**IEEE 802.11**  
**Wireless Access Method and Physical Layer Specifications**

**Title:**           **Proposed Updates to the D1 Draft, Section 3**

**Abstract:**       **This paper proposes changes to the D1 Draft to reflect the resolution of comments on Section 3 during the May 95 meeting.**

**Action:**         **Adopt the changes in this paper to update the relevant portions of P802.11/D1**

**Figure 3-1: Construction of the SDE\_PDU**

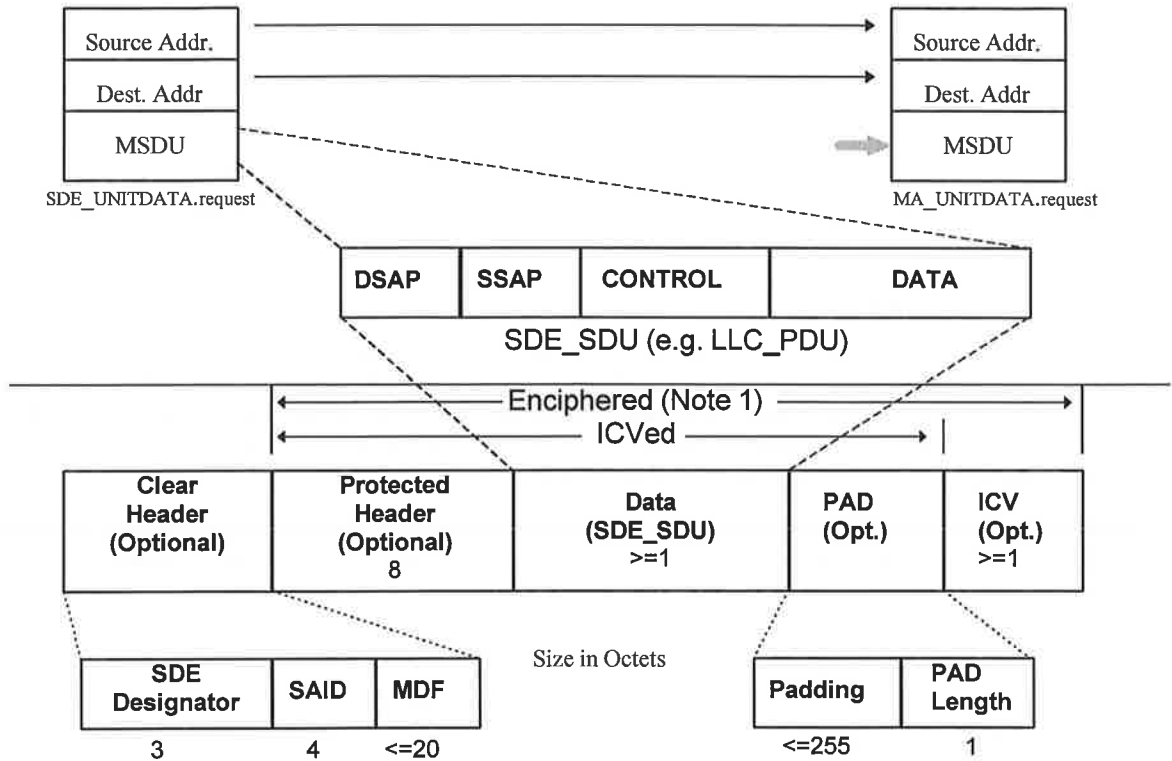
~~The IEEE 802.10 SDE [2] describes five parts to the SDE\_PDU: Clear Header, Protected Header, Data, Pad, and Integrity Check Value (ICV).~~

~~Only the data is required, all other parts are optional to the particular implementation and the security services provided by the application of the SDE. All implementations of 802.11 shall provide for encipherment of data using the default algorithm(s). The default encipherment algorithm is specified in section 5.4.~~

Figure 3-5: Connection Initiated by AP

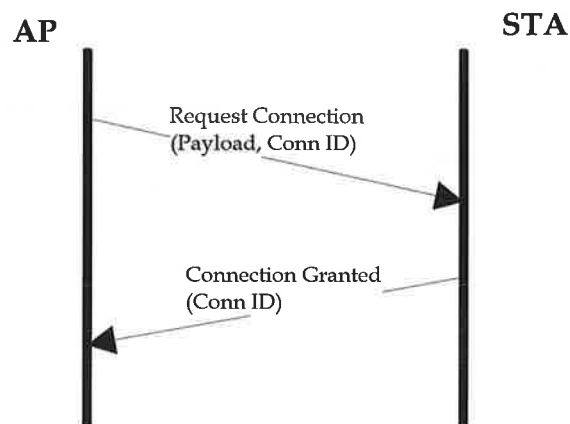
{For d1.2: Should "connection not requested due to traffic congestion" be indicated back to the requester?}
